## **Addendum No. 2**

January 14, 2016

CNG Fuel Facility  
Upgrades  
CIP Project#  
657A

AD2-AS903-1

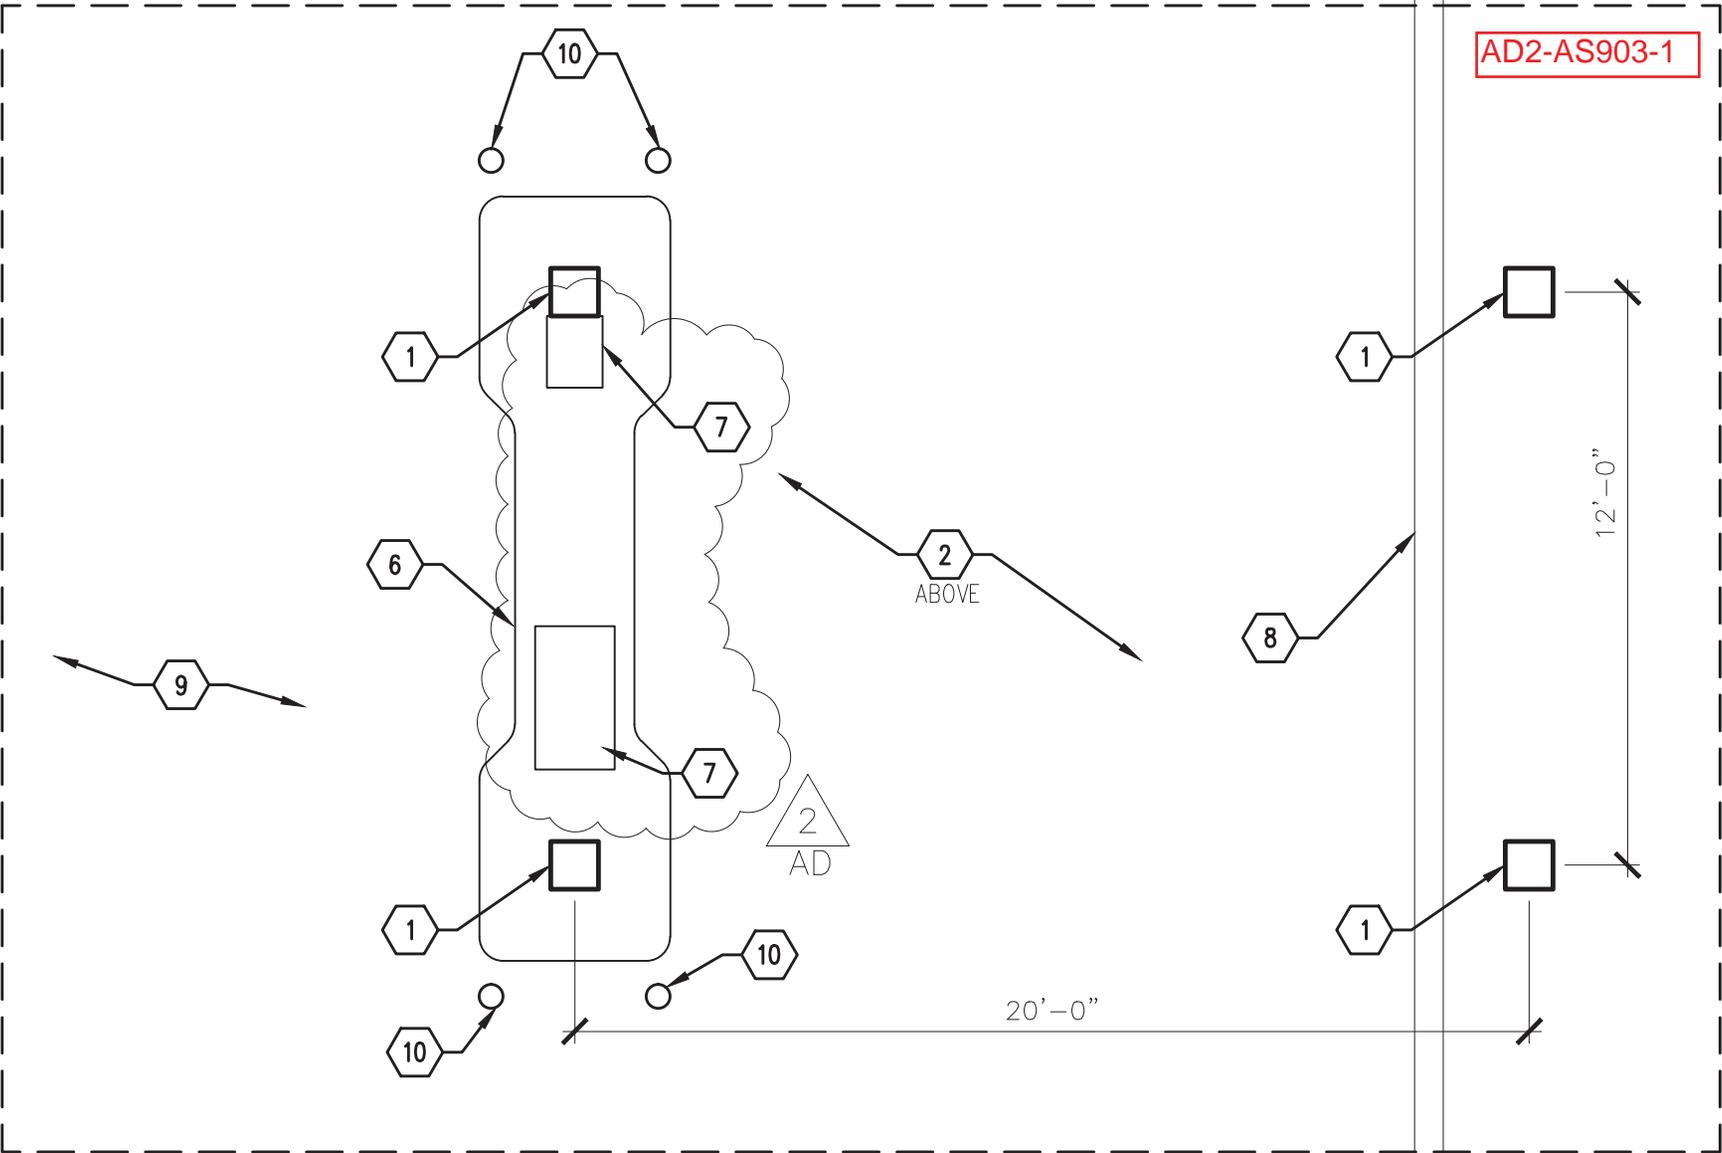
1. REVISE Cover Sheet to remove sheet DG-502 Equipment Schedule from Sheet Index as indicated on attached revised sketch AD2-COVER-1.
2. REVISE Sheet AS-101 drawing A1: Site Plan to revise location of public fast-fill island as indicated on attached revised sketch AD2-AS101-1.
3. REVISE Sheet A-903 drawing A1: Floor Plan to revise placement of Fuel Management Terminal and CNG dispenser as indicated on attached revised sketch AD2-A903-1.

C-100

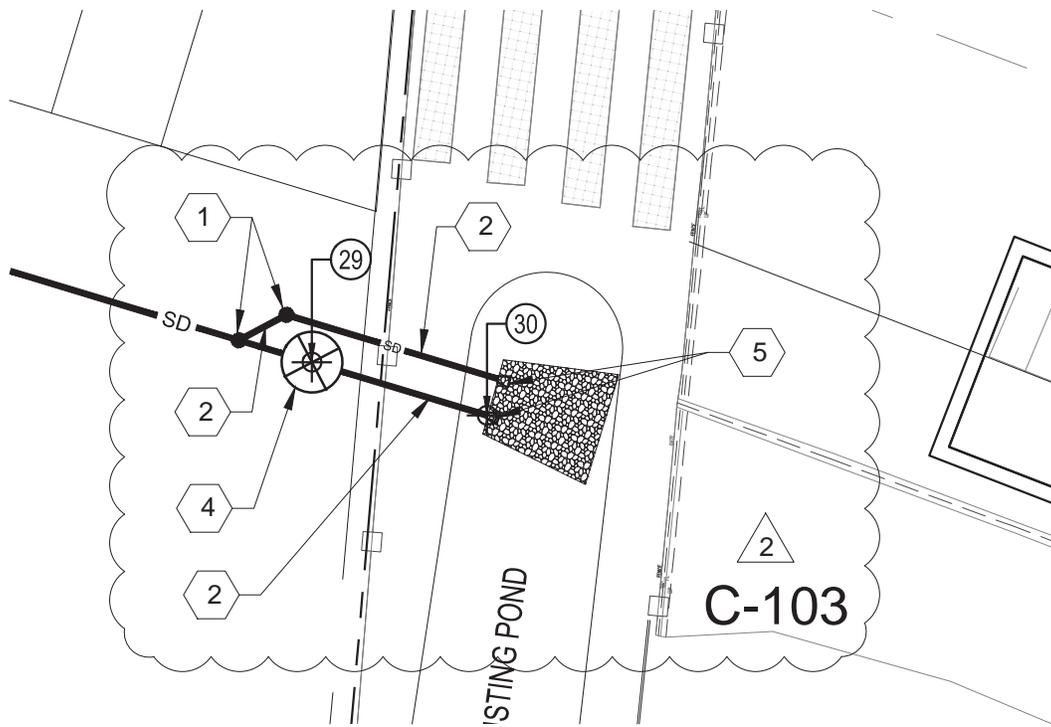
4. REVISE Sheet C-100 General Note 26 to revise R-value as indicated on attached revised sketch AD2-C100-1.
5. REVISE Sheet C-103 drawing A1: Utility Plan to add bypass line at oil water separator as indicated on attached revised sketch AD2-C103-1.

26. PAVEMENTS MUST MEET OR EXCEED R-VALUE OF ~~55~~<sup>50</sup>. IN AREAS LOWER R-VALVE MATERIAL, THE UPPER 2 FEET OF SUBGRADE SHOULD BE REMOVED AND REPLACED WITH R-VALUE ~~55~~<sup>50</sup> OR GREATER MATERIAL.

B4 THICKENED EDGE CONSTRUCTION JOINT DETAIL

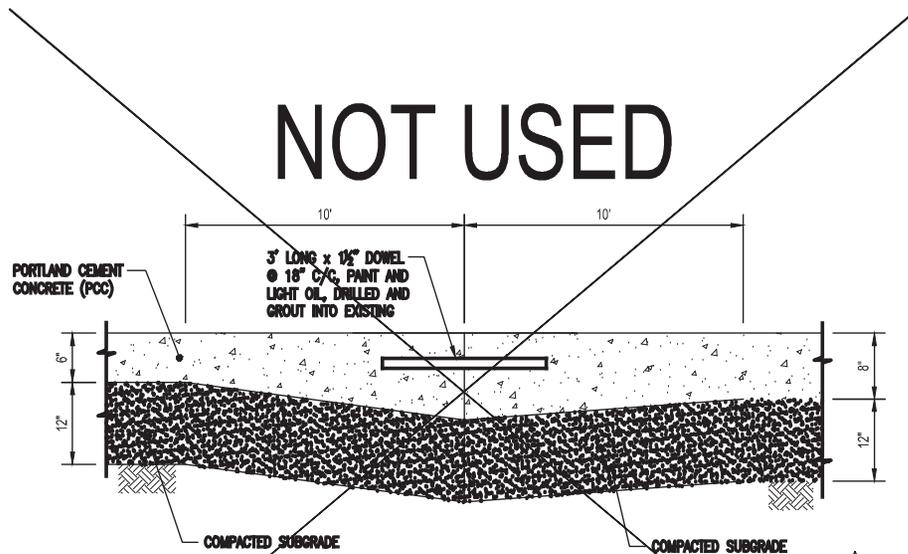
Response: Please refer to revised sketch.
  - e. Detail B4 on Sheet C-501 calls for a thickened slab at the construction joint. The detail doesn't say how thick the slab should be at the joint. Please clarify when Detail B2 and Detail B4 should be used. They are both construction joints, but one has a thickened slab.

8. DELETE Sheet C-501 drawing B4: Thickened Edge Construction Joint Detail as indicated on attached revised sketch AD2-C501-2.
9. REVISE Sheet C-501 drawing C1: Trench Drain Detail to add dimensions and revise other notes as indicated on attached revised sketch AD2-C501-3.

Response: Please refer to revised sketch.
  - f. Is the thickness of the new concrete fueling pads 4" or 6"? Conflict on sheet C-501.

D1

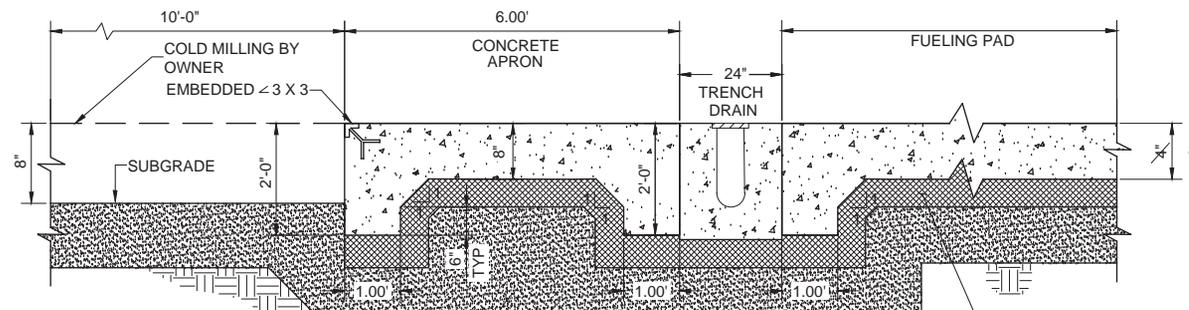
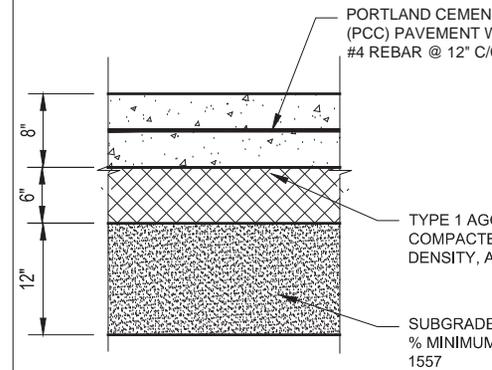
10. REVISE Sheet C-501 drawing D1: Asphalt Pavement Section to revise asphalt section and other notes as indicated on attached revised sketch AD2-C501-4.

**8" PORTLAND CEMENT CONCRETE PAVEMENT SECTION**

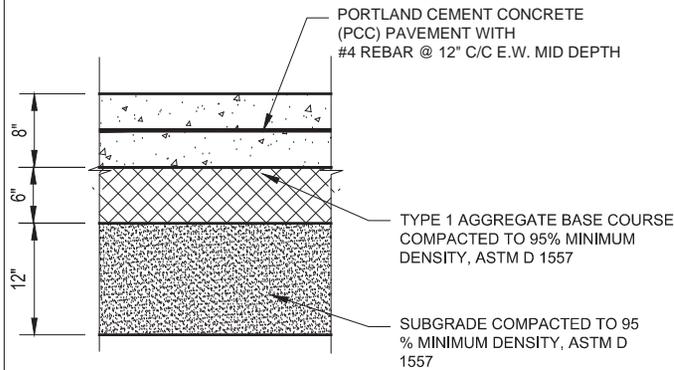
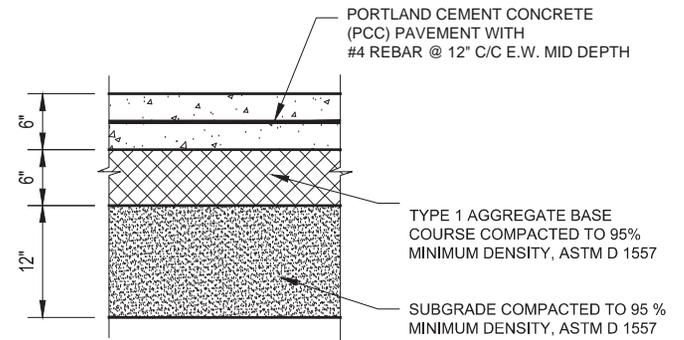
11. REVISE Sheet C-501 drawing D3: 8" Portland Cement Concrete Pavement Section to revise section depth as indicated on attached revised sketch AD2-C501-5.

Response: The concrete fueling pads shall be 8" thick. Please refer to revised sketch.

**A1** **CMU WALL FOUNDATION DETAIL** **A**  
SCALE: 3/4" = 1' - 0"

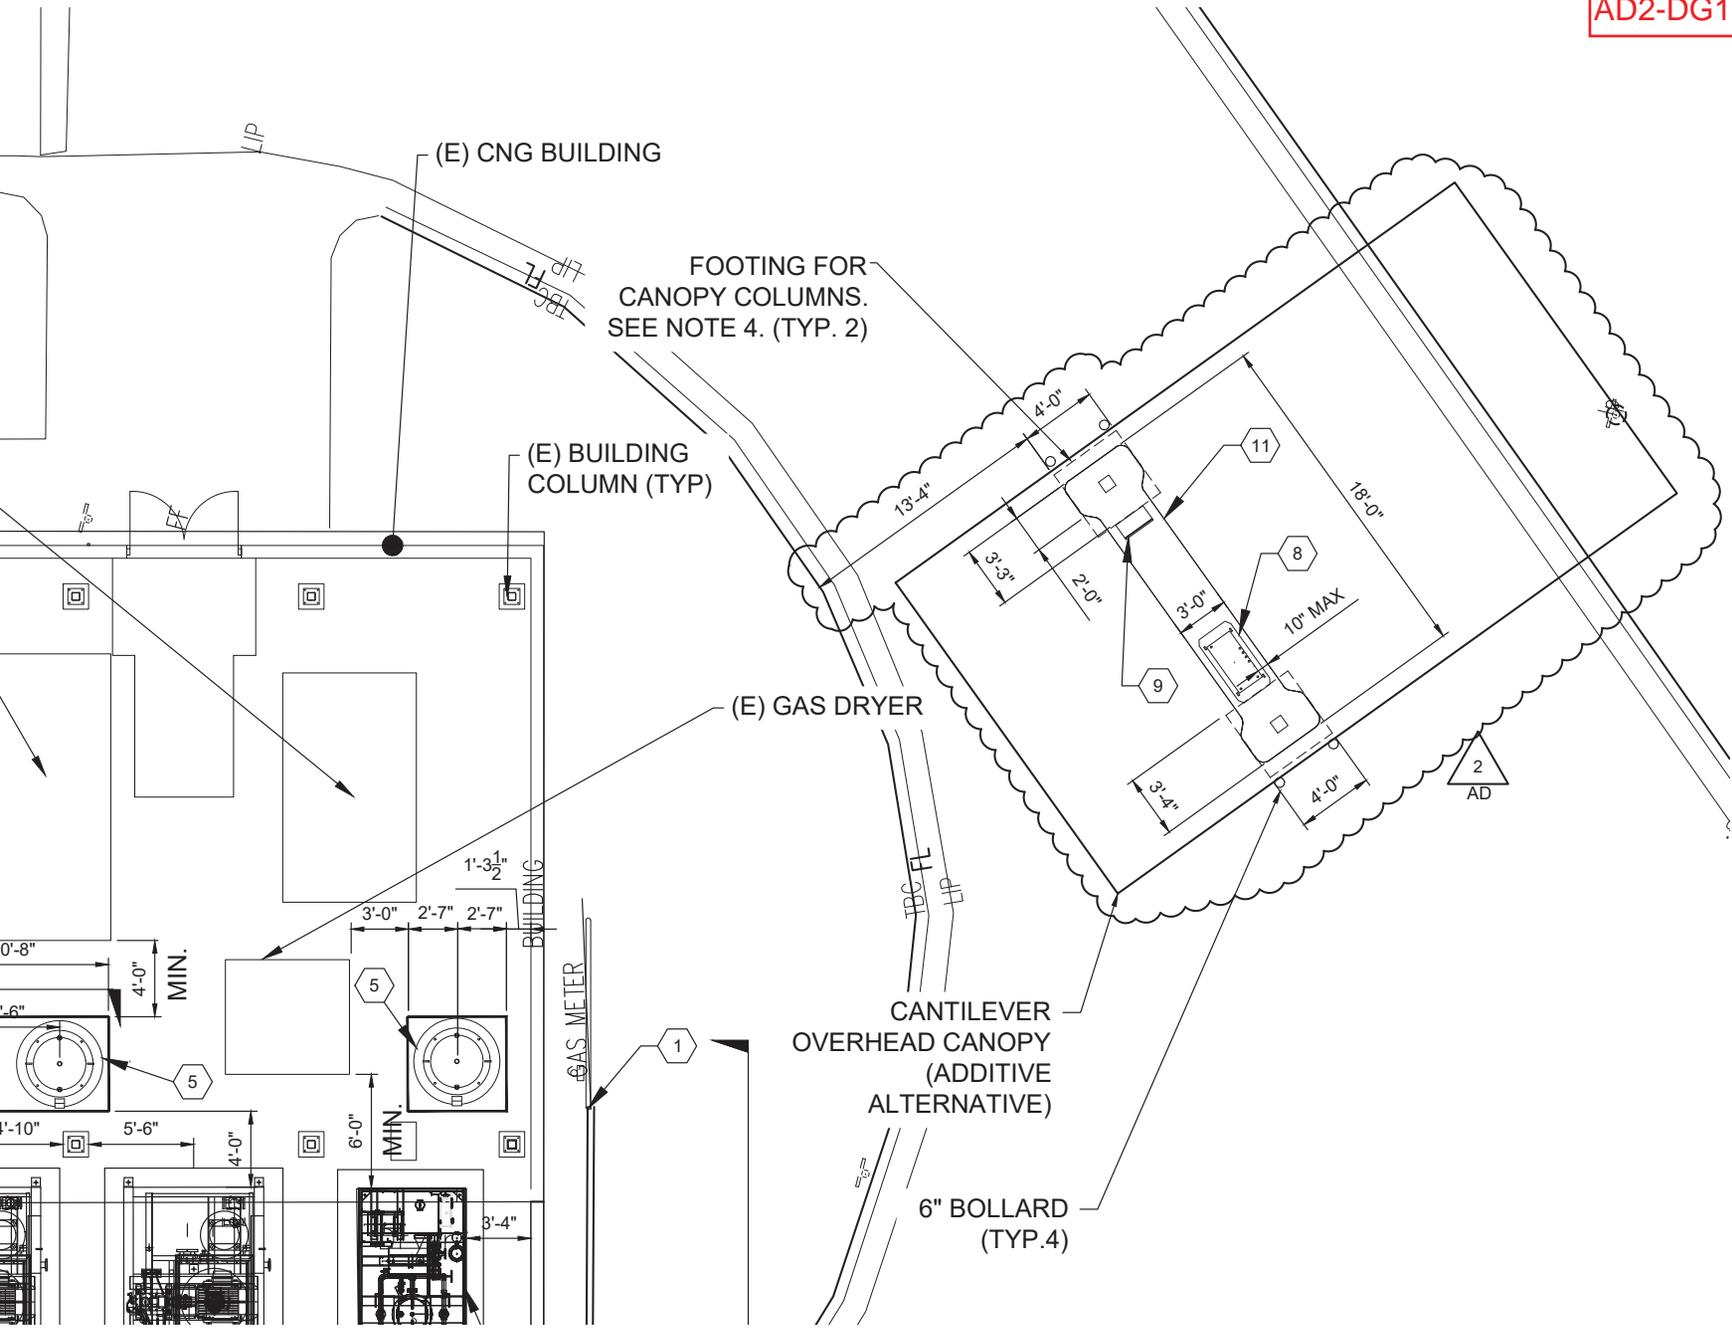
1. The following questions were received during bidding. Answers are provided as follows:
  - a. Keynote #1 on Sheet S-201 calls for the CMU reinforcing to be #5 @ 24". Detail A1 calls for the footing dowels to be #5 @ 16" to match wall reinforcing. Please clarify the CMU wall reinforcing.

12. REVISE Sheet S-201 drawing A1: CMU Wall Foundation Detail to revise reinforcing spacing as indicated on attached revised sketch AD2-S201-1.

Response: The detail should read #5 @24". Please refer to revised sketch.
  - b. Keynote #1 on Sheet A-102 calls for sawcut control joints at 20' and expansion joints at 60'. Sheet C-104 shows doweled construction joints, sealed joints, construction joints or contraction joints. These joints are shown at 10' max. Sheet C- 501 has five different joint details. Please clarify what kind of joints are required in the slabs, and what spacing is required.

**13** DEFUELING FLOW SCHEMATIC  
NTS

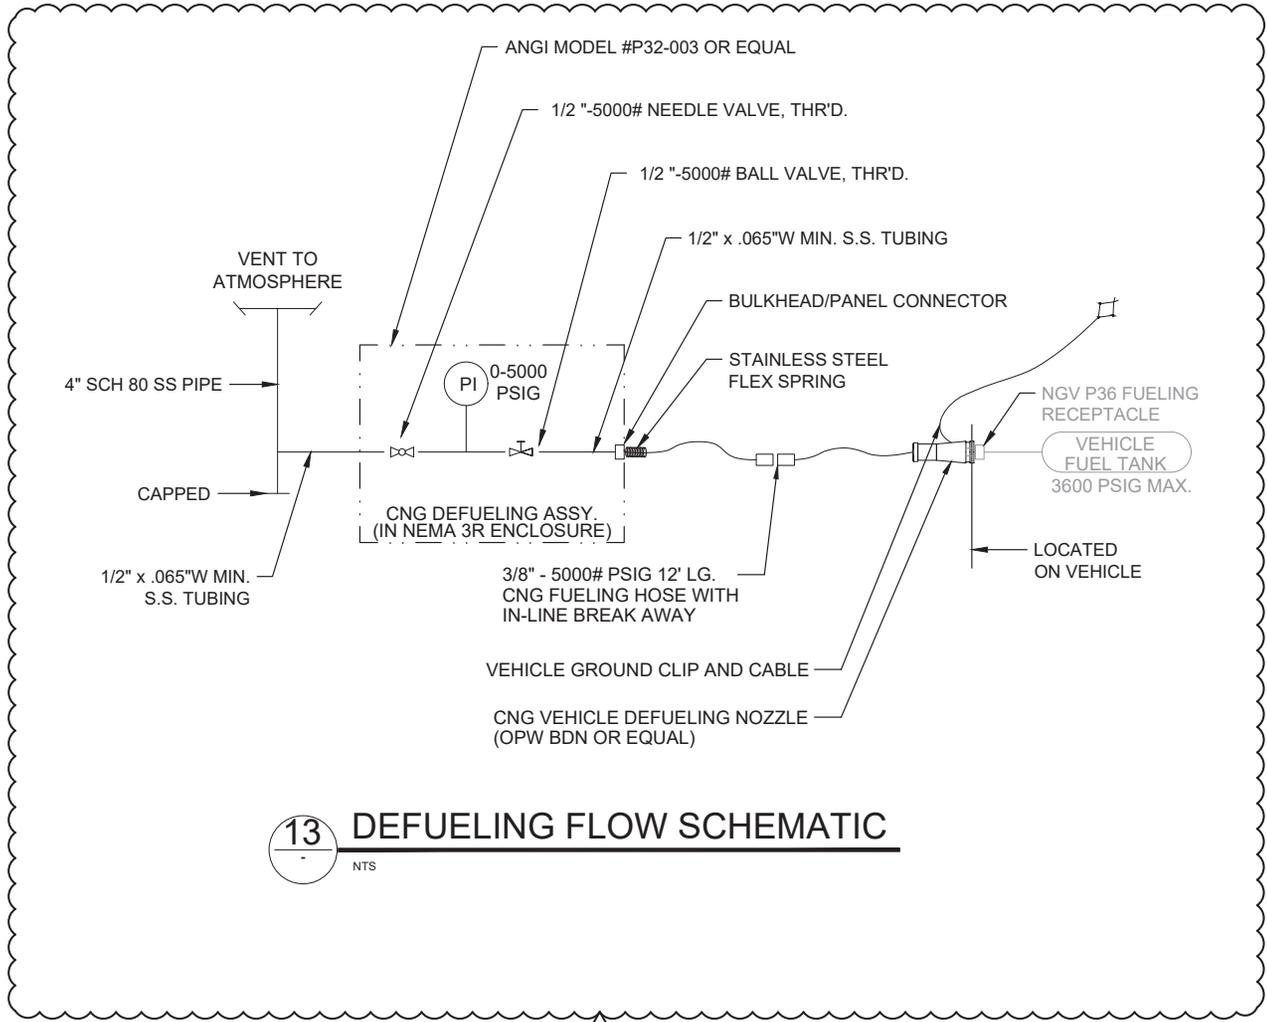
## **Process Gas**
